Access Compliance Report

Public Rights-of-Way (Curb Ramps)

Intersection ID: N/A	Main Street: S_BREVARD_ST	Cross Street: E_STONEWALL_ST	Location: SW
ADA ID: FCEED38AC765	Ramp Type: Directional1	Initial Pass/Fail: Pass	Overall Compliance: No
Severity Score: 0			
Codes/Mitigation Info/Possible Solution		Field Measurements/Component Compliance

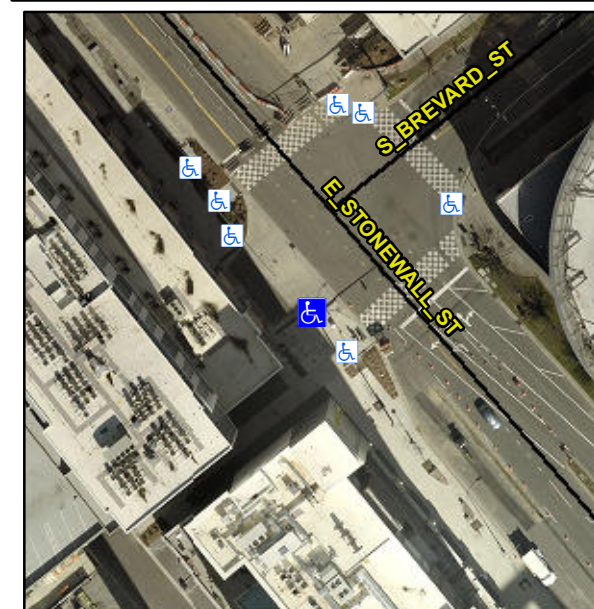
Remove & Replace Detectable Warning System.

R305.2
